MILITARY SPECIFICATION

RESISTOR-CAPACITOR NETWORK, FIXED FILM RESISTORS AND CERAMIC CAPACITOR, STYLE RZ120, 16 PIN FLAT PACK

This amendment forms a part of MIL-R-83401/12, dated 9 March 1987, and is approved for use by all Departments and Agencies of the Department of Defense.

FIGURE 2, delete and substitute:

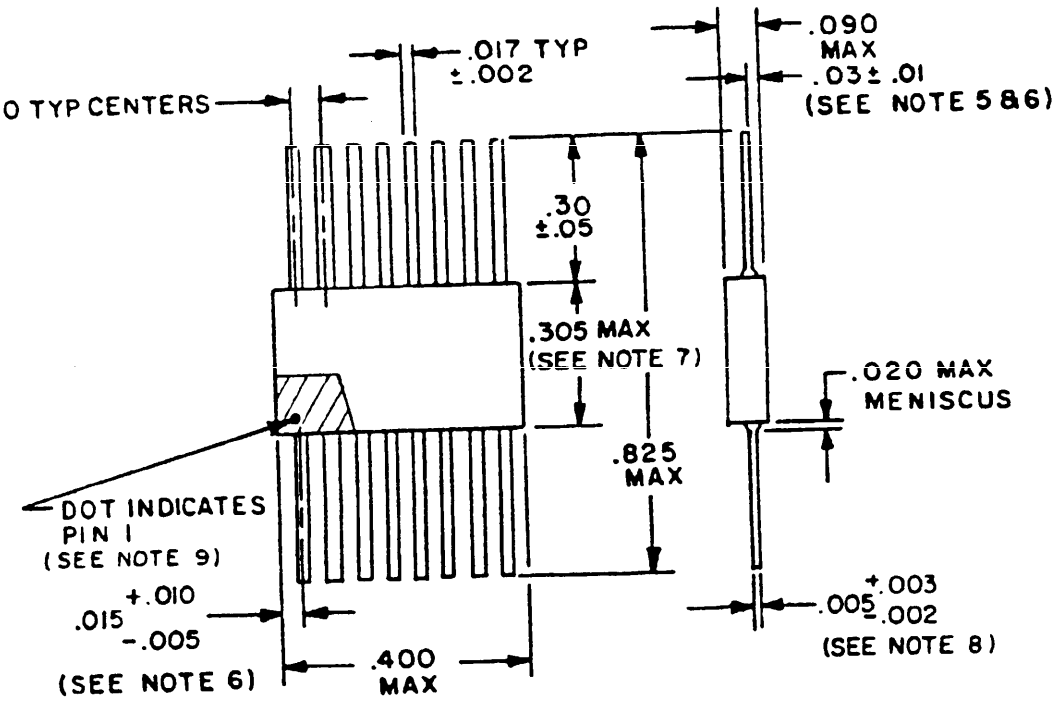
FIGURE 2, add new note 9:

"9. Pin 1 locator shall be a dot, notch, stripe, or numeral 1 adjacent to pin 1, in the shaded area."
